BULLETIN NO.: 08 - 80

SUBJECT: CR-2020

BULLETIN NO.: 07-81

SUBJECT: CR-2020

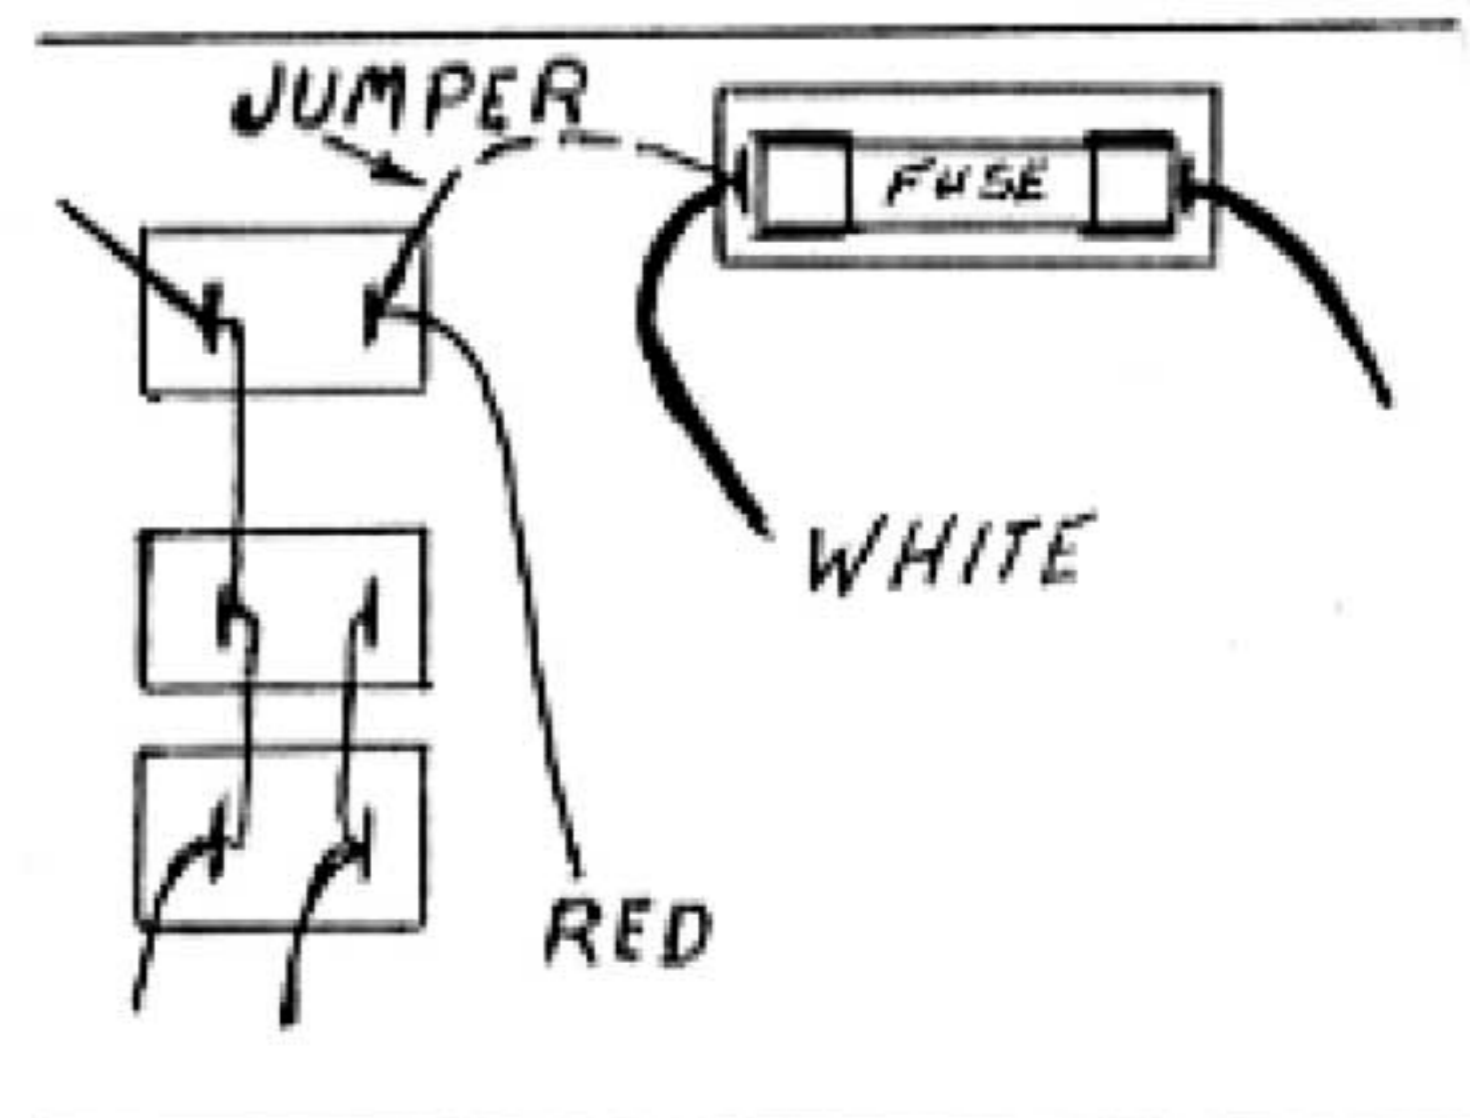
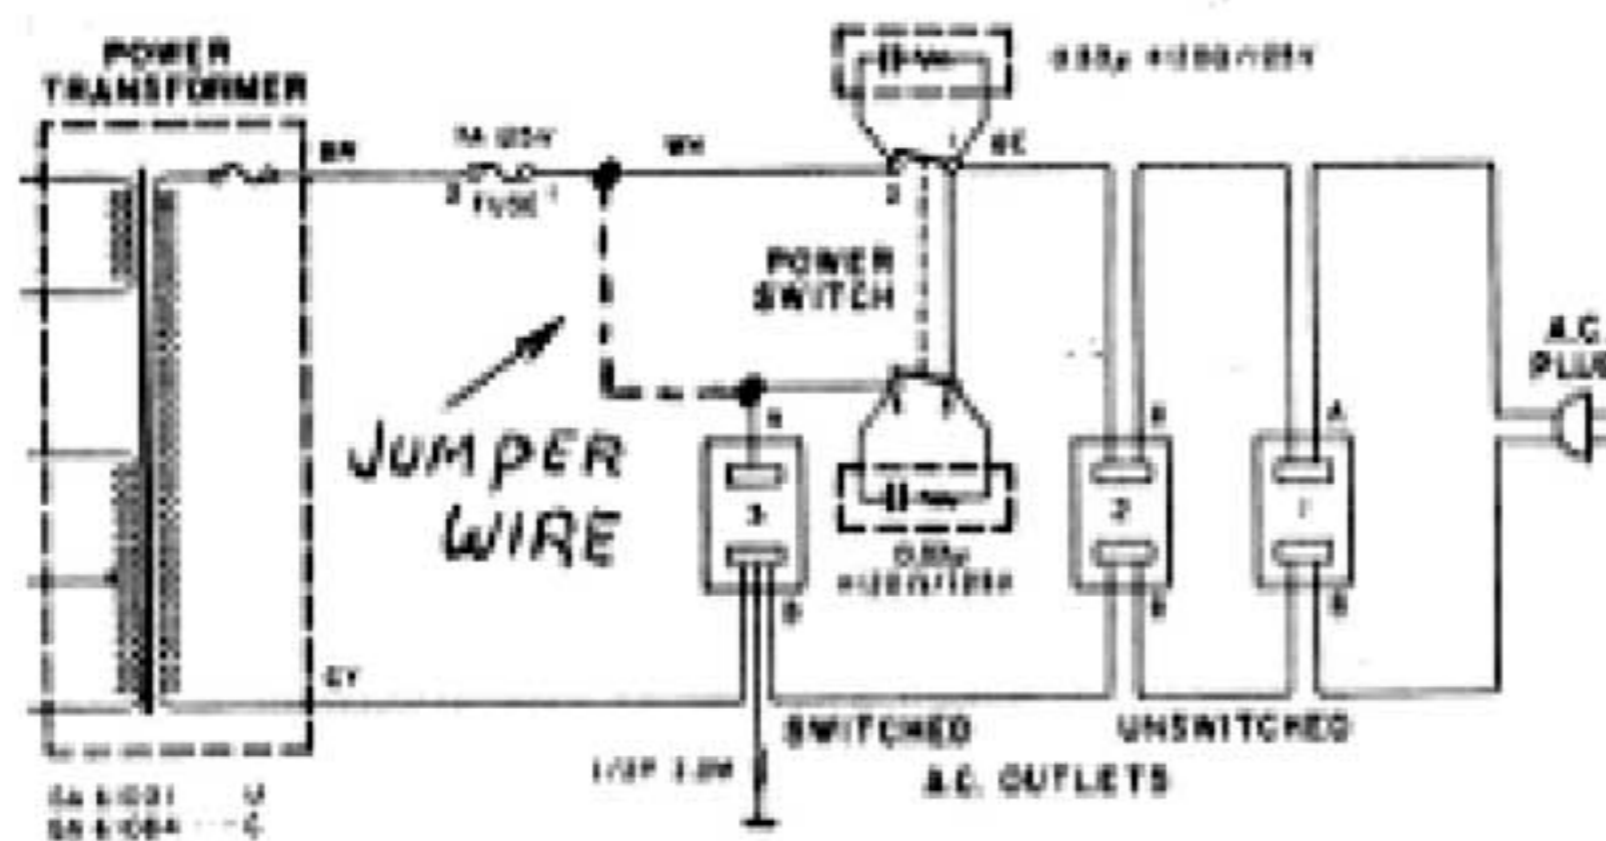
Problem: Power switch failure.

Cause: Pitting and burning of switch contact due to high current spike when set is switched off. (Back E.M.F. from power transformer).

Remedy: Replace power on/off switch (KA200630).  
Install a jumper wire between the fuse holder (white wire) and the switched AC outlet (red wire).

Install the jumper wire on all units received for service that have not been modified.

### ELECTROLYTIC CAP. C. BOARD

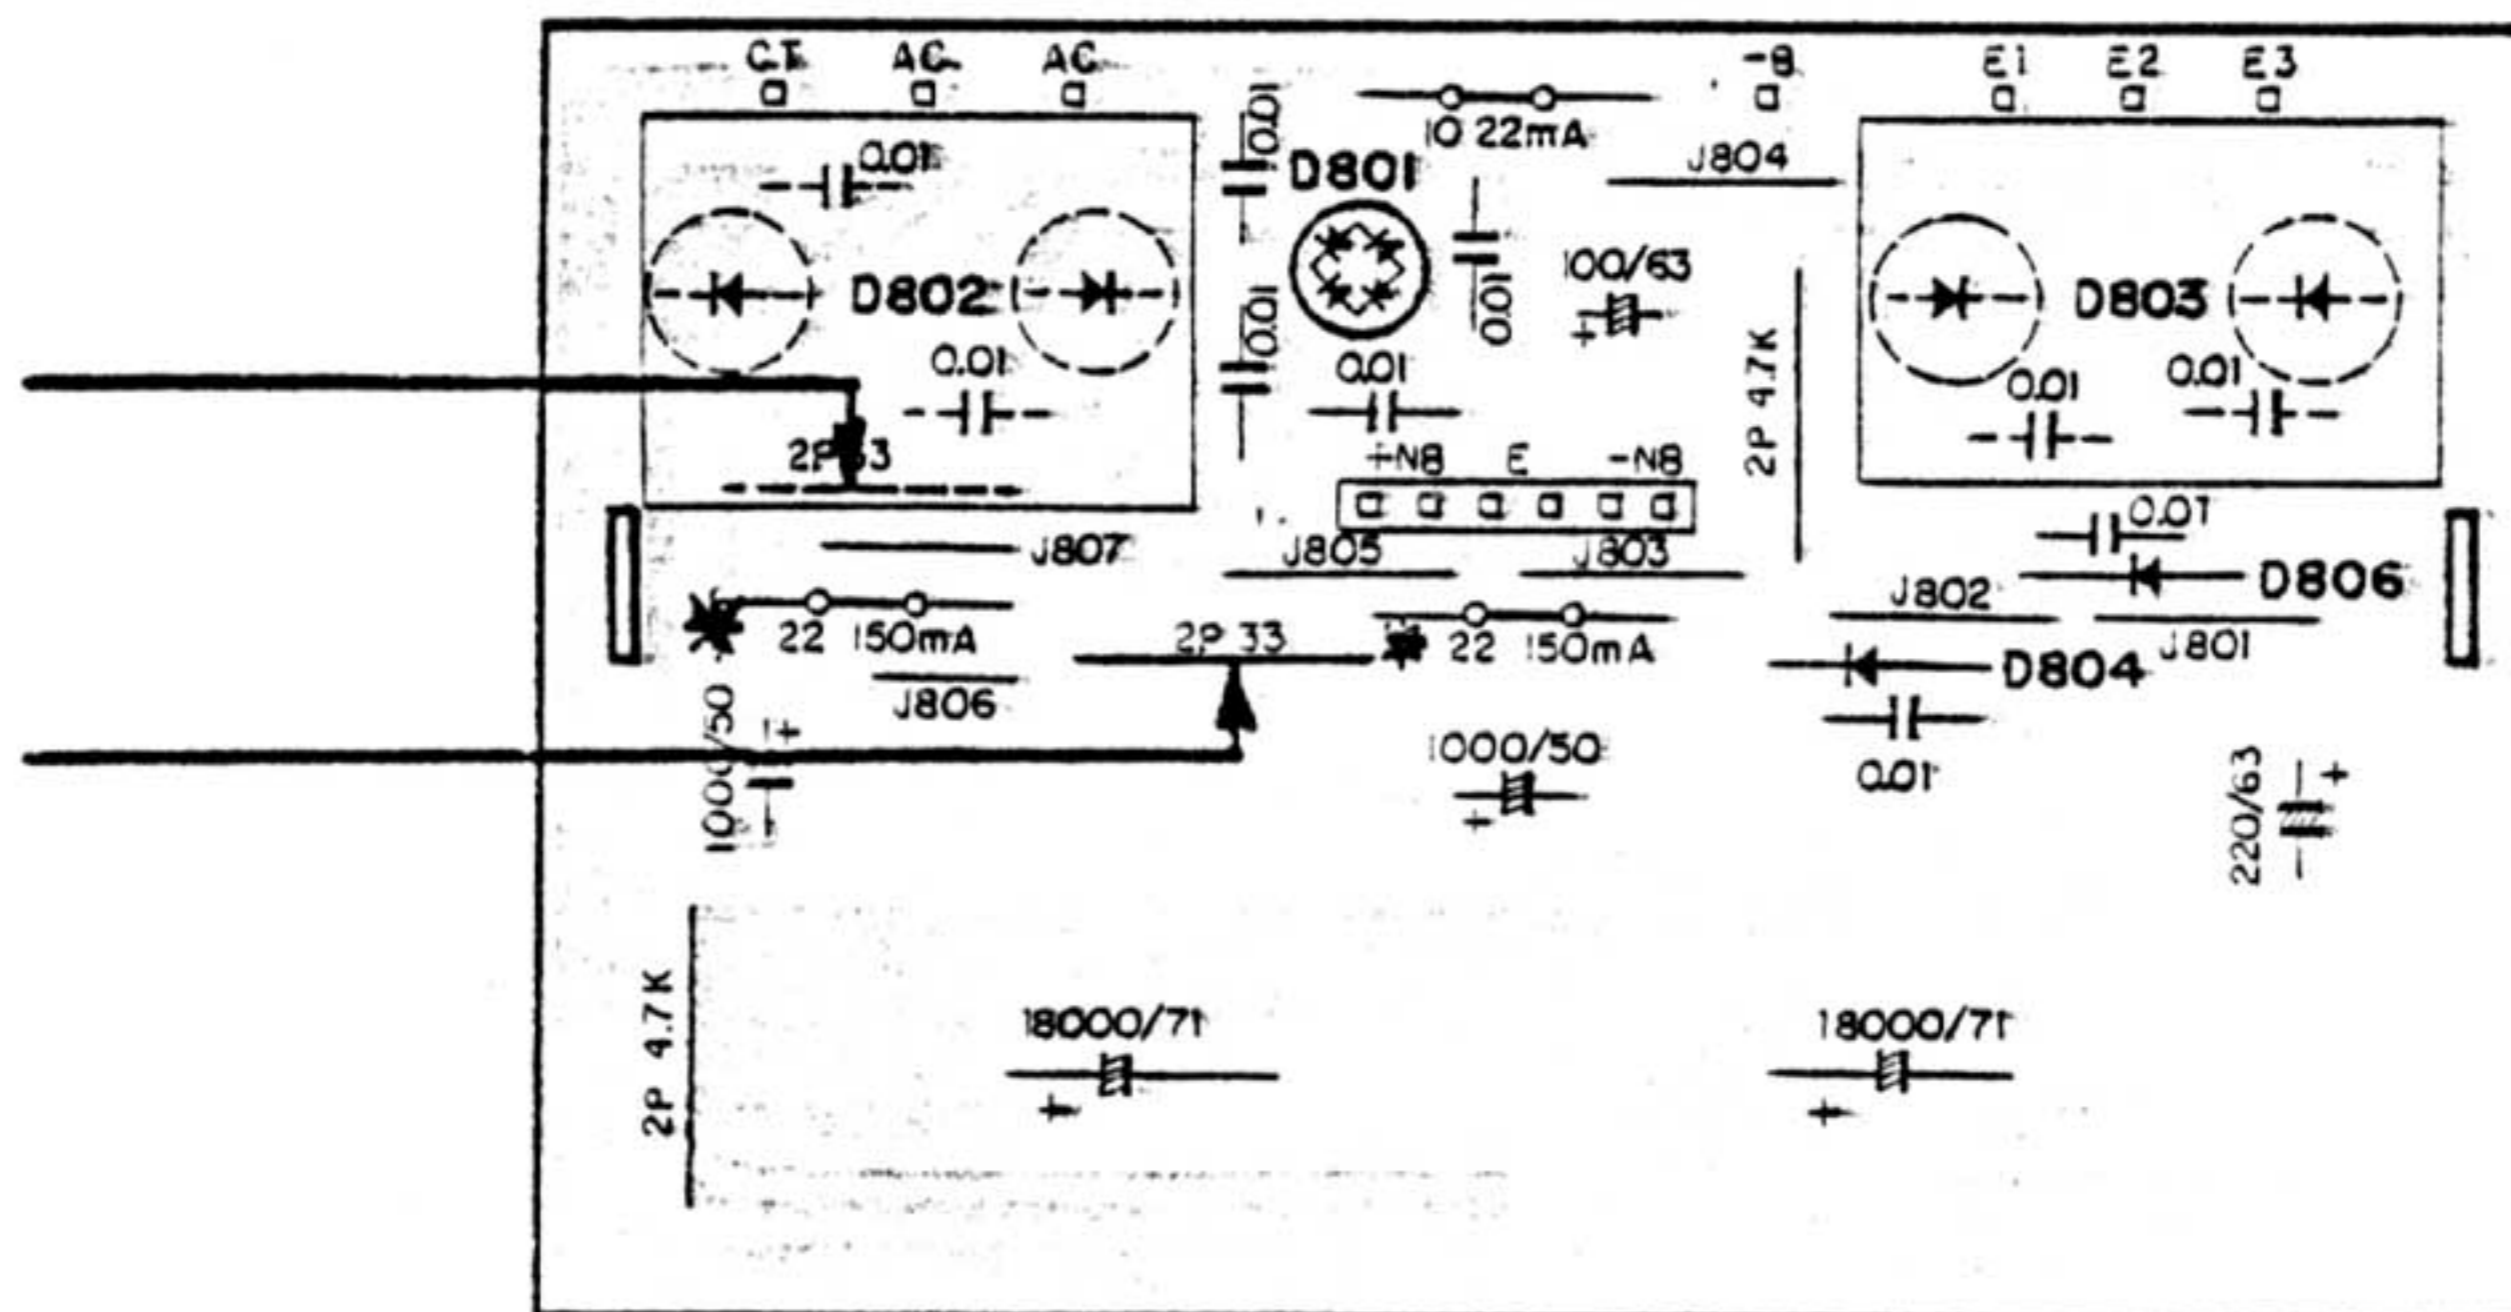
Problem: Intermittent power supply.  
Receiver goes on and off, speaker relay clicking.

Cause: R 801 and R 802 (33 ohm) in electrolytic capacitor circuit board get hot and unsolder themselves.

Remedy: Remove both resistors and install new 33 ohm, 3 $\frac{1}{4}$  watt wire wound resistors.

Mount the resistors approximately  $\frac{1}{4}$  inch away from the circuit board.

We suggest to use Ohmite #4374. These resistors are available from Yamaha Canada Music, Parts Department.

\* Also replace the 22 ohm 150 mA fuse resistors with Ohmite #4369 22 ohm 3 $\frac{1}{4}$  watt resistors.
